SUMMARY OF CONCERNS IN RELATION TO THE PROPOSED NORTHCONNEX TUNNEL

This is an objection to many aspects of the proposed NorthConnex tunnel.

SECTION A: THE CONNECTIVITY OF NORTHCONNEX SOUTHERN VENTILATION FACILITY AT THE SOUTHERN INTERCHANGE, THE SOUTHBOUND TUNNEL IN PARTICULAR

MOTORWAY OPERATIONS COMPLEX - SOUTHERN VENTILATION FACILITY - SECTIONS
M1-M2-5000-DR-JD-0525

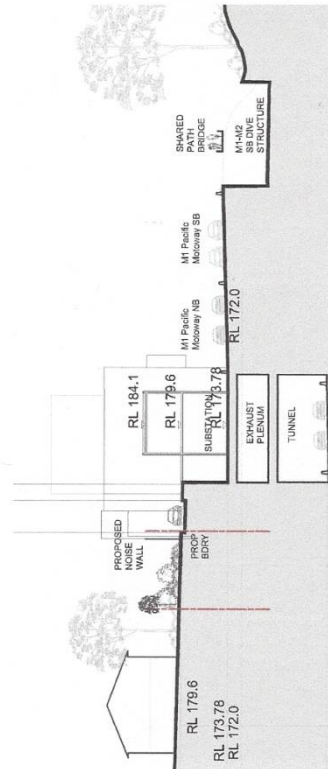
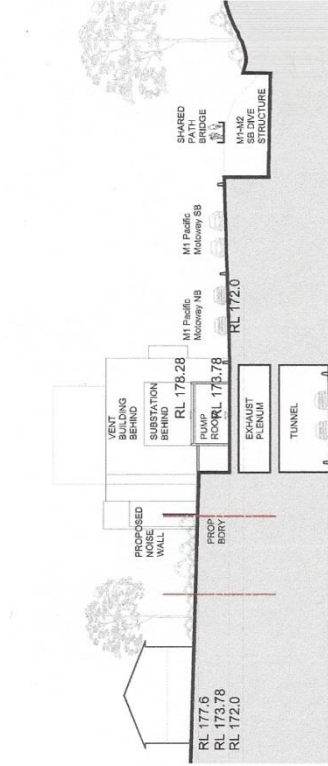
5. *EIS Volume 4, Technical working papers - Urban Design, 6.0 Operational Ancillary Facilities*
EIS Page 99 there is the diagram "Motorway Operations Complex – Southern Ventilation Facility – sections. *Page 10 below* The diagram has the cryptic label "Connection to tunnel TBC". What does TBC stand for? To be considered? Why is tunnel singular? Which tunnel is the diagram referring to northbound or southbound? There is no diagram showing any connection from the Southern Interchange ventilation facility to either the northbound or the southbound tunnel in any way AND YET

- Diagrams need to be provided showing the inter-relation between the shaft, the ventilation outlet and the motorway operations centre with a clear description of what is to be constructed and how it will operate.
- The community needs irrefutable evidence that the polluted air from the southbound tunnel exit portals will not be allowed to flow like an invisible sewer through West Pennant Hills, North Rocks, Carlingford and Beecroft.

MOTORWAY OPERATIONS COMPLEX - SOUTHERN VENTILATION FACILITY - SITE SECTION 1-1
M1-M2-5000-DR-UD-0713

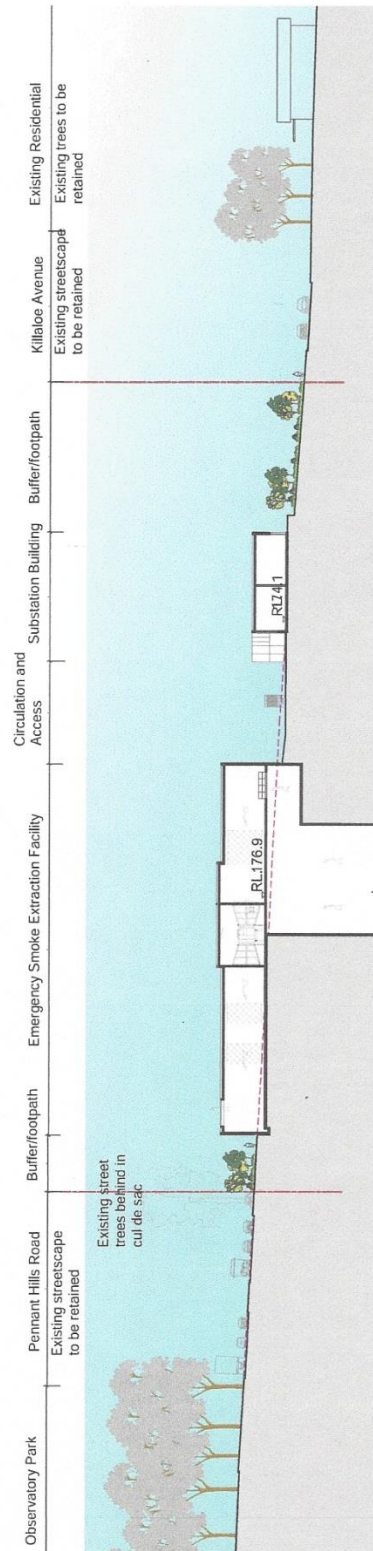
6. *EIS Volume 4, Technical working papers Urban Design, 8.0 Landscape Design*
EIS Page 176 is the diagram "Motorway Operations Complex – Southern Ventilation Facility – Site 1-1". *Page 13 below* The diagram does not show any connection to either the northbound or southbound tunnel. In the same Landscape Design section, EIS Page 182 is the diagram "Wilson Road Tunnel Support Facility –Section" *Page 14 below* which clearly shows the connection to the tunnels. In the same Landscape Design section, EIS Page 189 is the diagram "Northern Ventilation Facility – Landscape Concept Section". *Page 15 below* This also clearly shows the connection to the tunnels.
